**ISSUE:** Certificate of Appropriateness for alterations

**APPLICANT:** Waterford Place Homeowners Association

**LOCATION:** Old and Historic Alexandria District  
150 Waterford Place

**STAFF RECOMMENDATION**

**Waterford Place Homes Association  
Entrance and Mailbox Improvements**

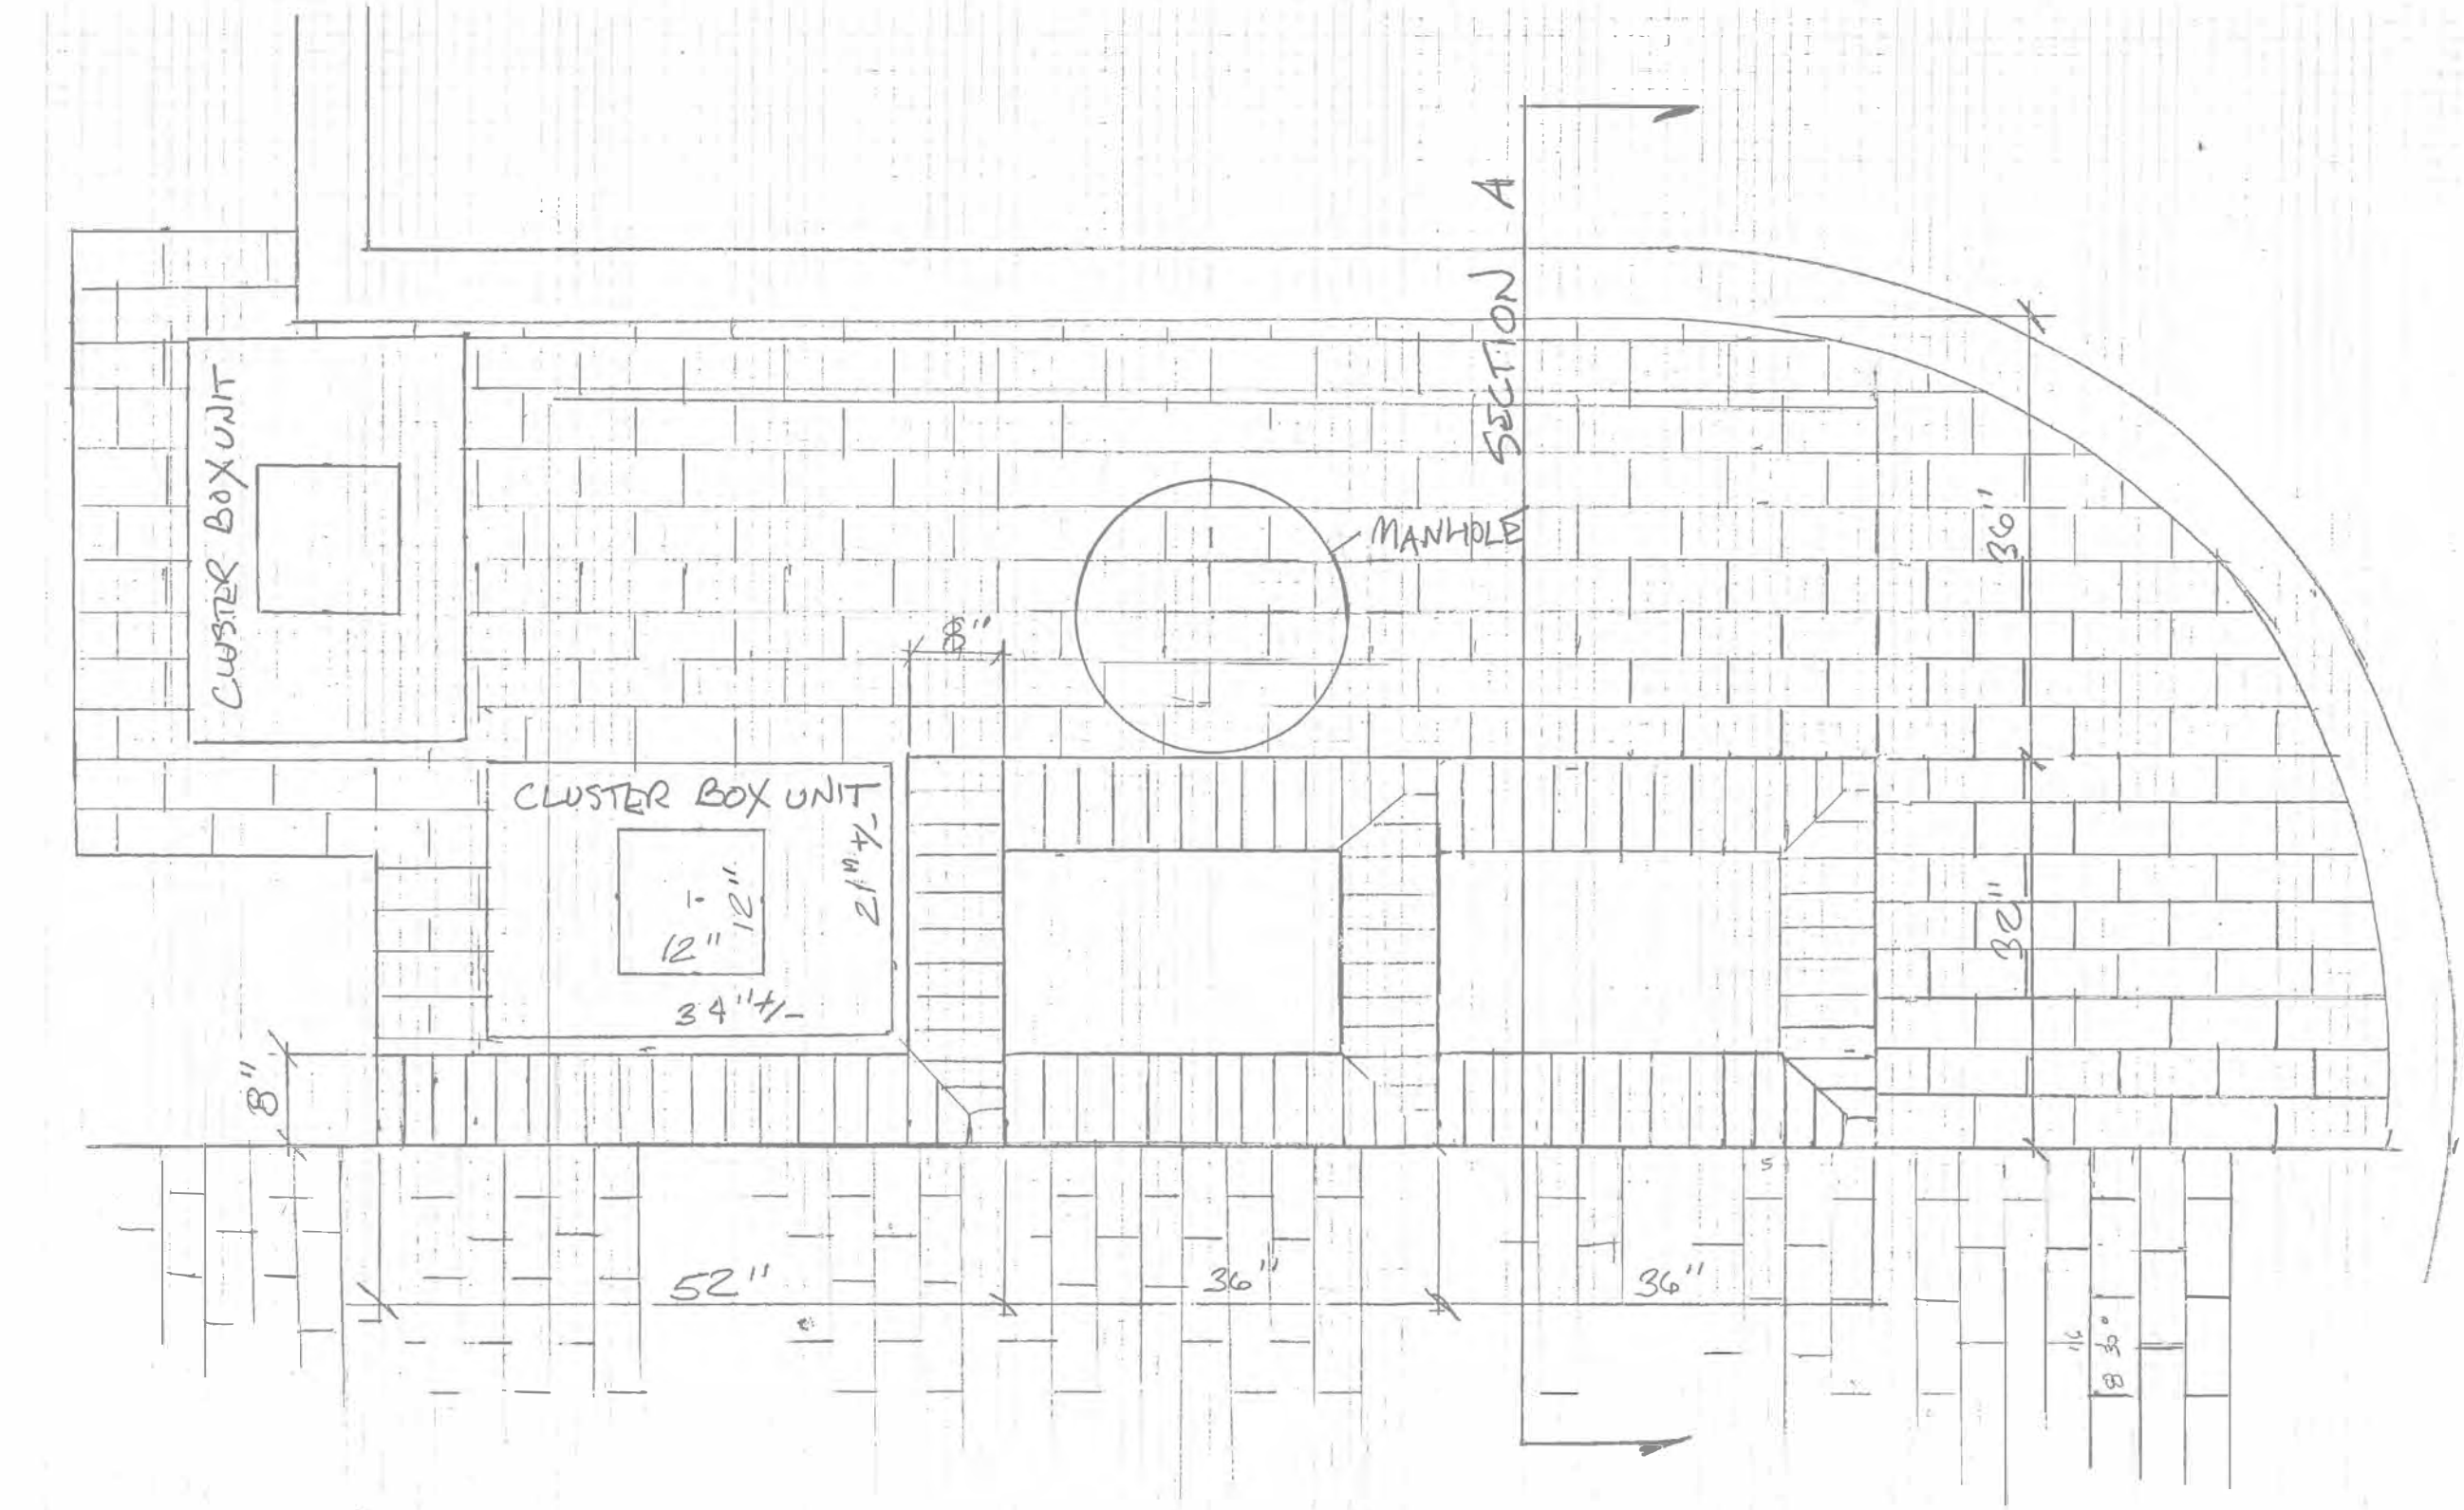
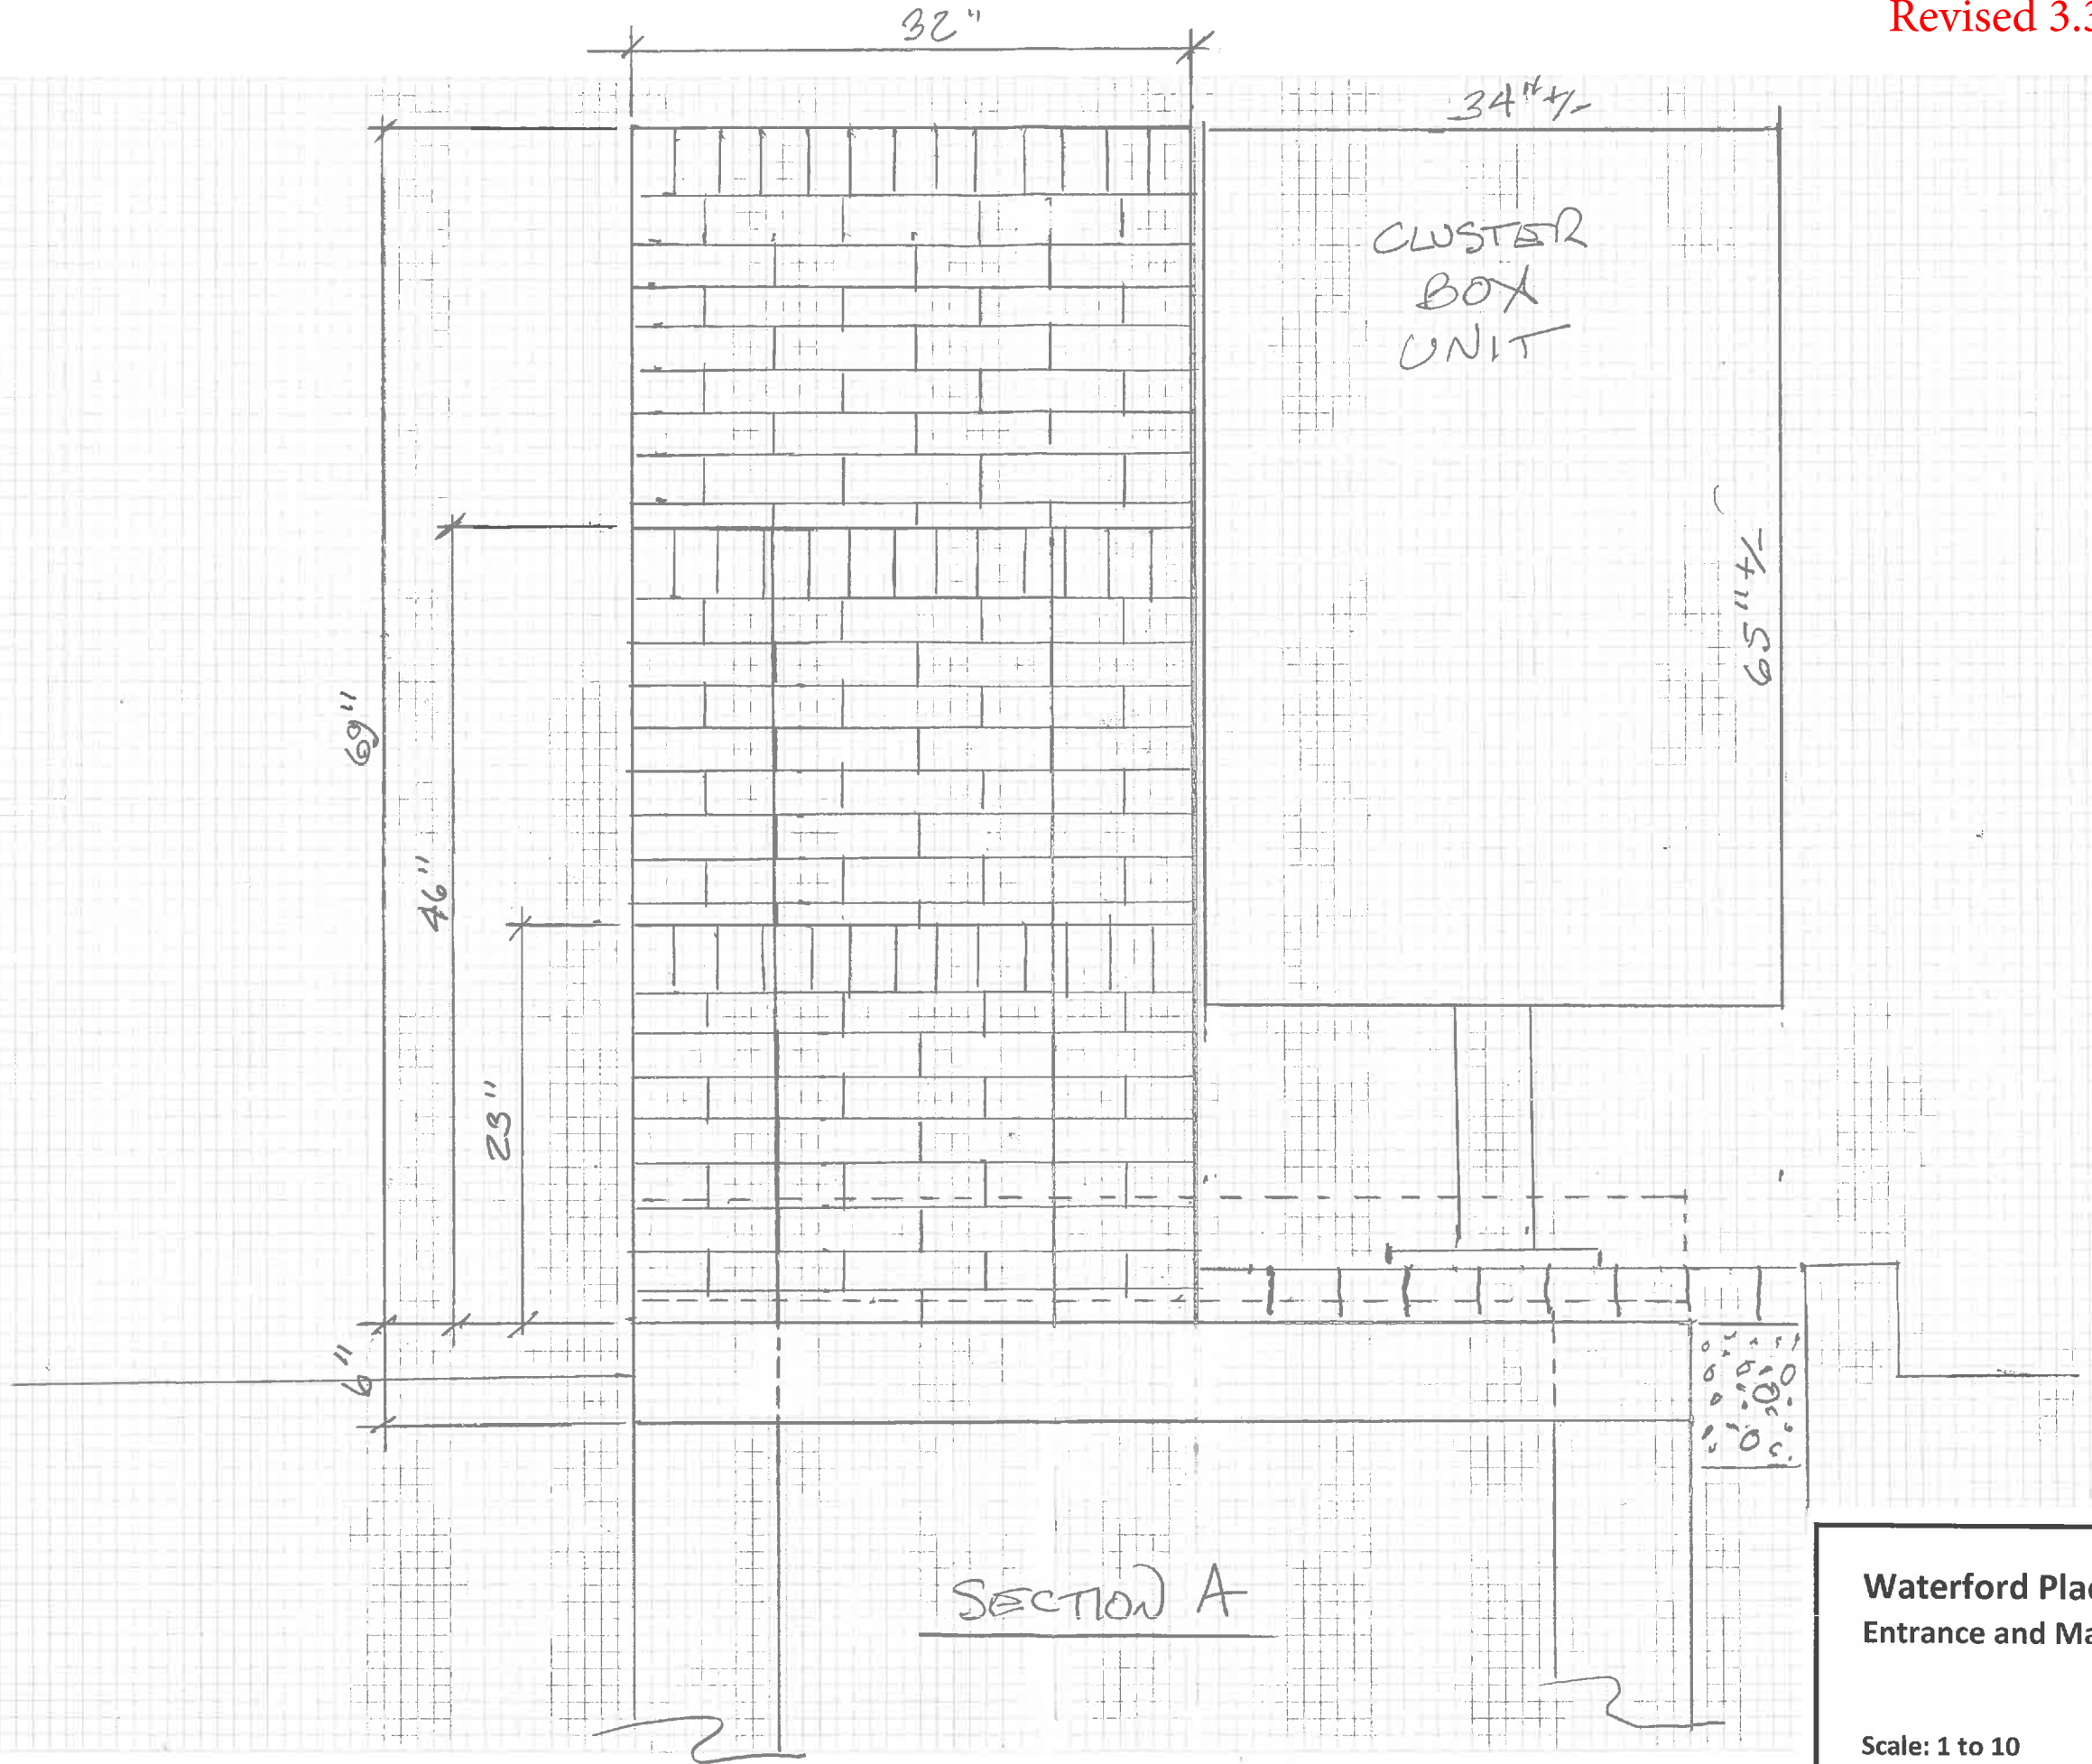
Even though the proposed wall is not considered a garden wall but a screening landscape feature that will block the new mailbox structures and parking from public view, the *Design Guidelines* states that “Masonry fences and walls of brick or stone are generally appropriate throughout the historic districts.” Moreover, there are several brick walls screening parking lots of townhouse

complexes within the Old and Historic Alexandria District. Currently, the unattractive existing mailbox structure faces South Union Street (Figure 2). Staff finds the proposed planter/wall to be appropriate and an enhancement to the Waterford Place complex.

- C-1 Please provide wall heights and location of proposed light fixtures.
